Land at Coleshill Street Miles Platting

Drawing number	Rev
3547A - LEV - 00 - XX - DR - A - 1640	P3

Drawing	Date
Plot E - Proposed Perimeter Elevations	08/11/19

LB Note: 24.02.2021
This drawing has been updated as part of the Section 96a application. Please see adjacent notes for elevation updates.

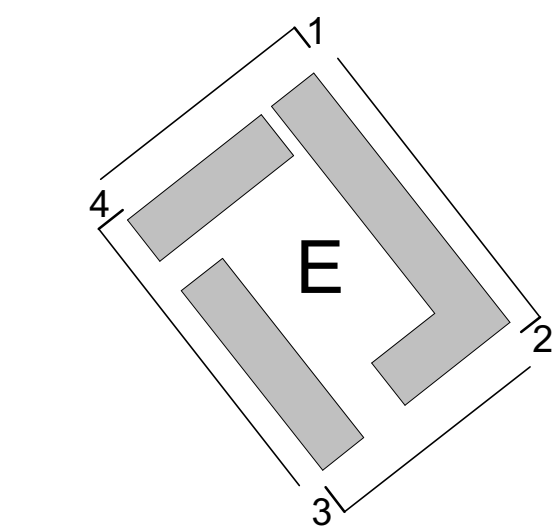
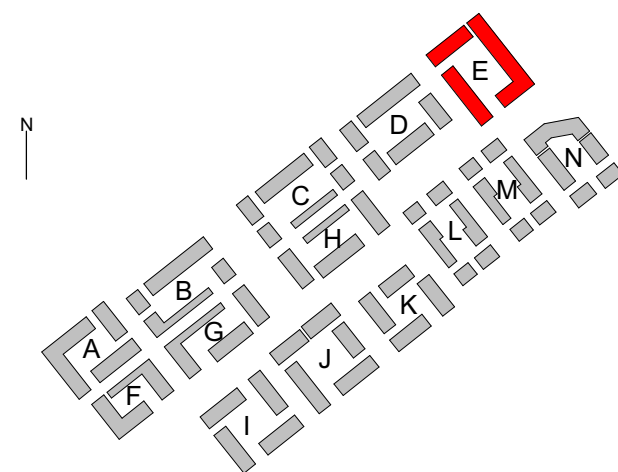
Where the top floor is flush with the facade below at the entrance from Hulme Hall Road the brick coursing from below will continue and will form a marker

Replacement of metal cladding to top floor of apartments with facing brickwork with recessed banding

Replacement of metal cladding to top floor of apartments with facing brickwork with recessed banding

Item 07. Change pre-cast concrete canopies to houses to PPC pressed aluminium clad canopies which retain the same size and form.

Item 18. Change pre-cast concrete dwelling garden dividers to the Canal Tow Path houses to brick walls retaining house numbering

Item 19. Omit pre-cast concrete cladding to Tow Path facing houses with textured brick detailing

Corrugated metal cladding omitted.
Blue/grey Facing Brickwork Type 4 added which applies to Mews houses
Facing brickwork with recessed banding adds to top floor of Apartment Blocks E, J and N

General note: Floor to floor heights on all houses have been reduced from 3m to 2.7m
